ADDENDUM # 5

To: File 1805-909-23-4796
RFP for: Victoria Plaza Rehabilitation and Modernization

RESPONSES TO RFI ADDITIONAL QUESTIONS

RE: COSA Denial Comments dated 6/27/18 by Valerie Gleason on the Electrical Drawings for Permit 2380232

TP-1
Tree Preservation Plan

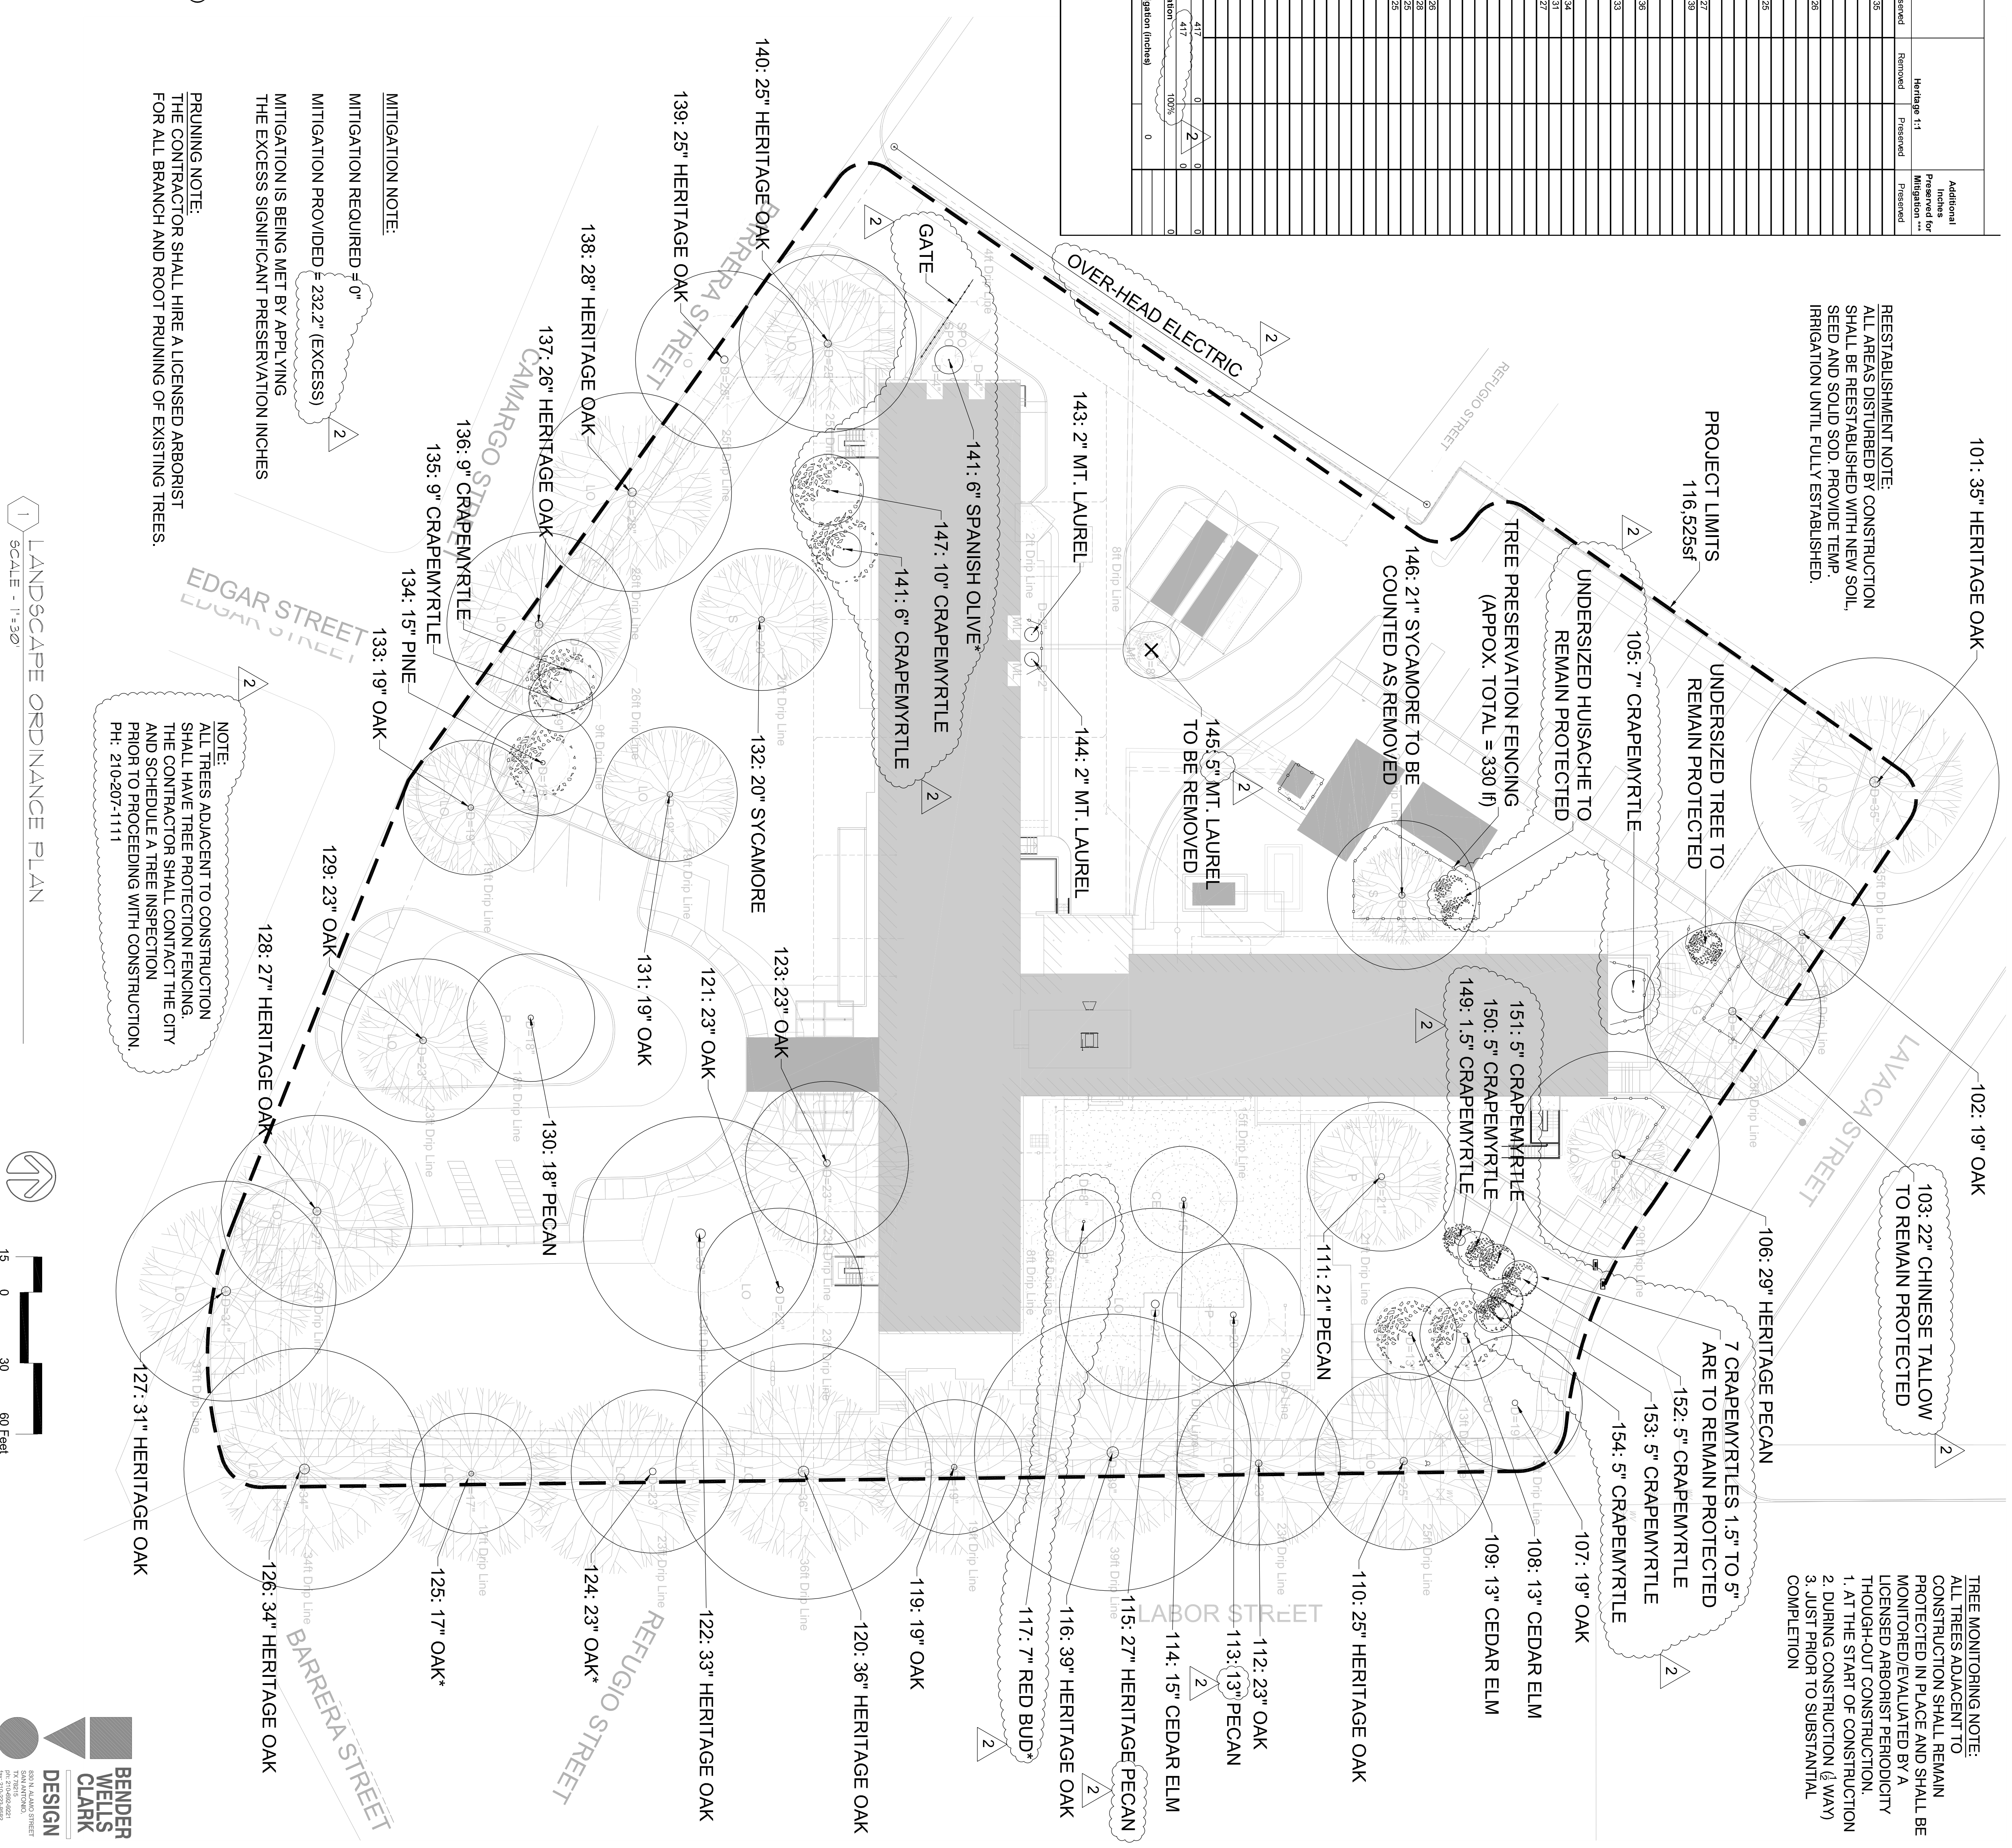
1. RFI questions and responses
2. COSA Plan Review comments and responses
3. New Tree Plan sheets
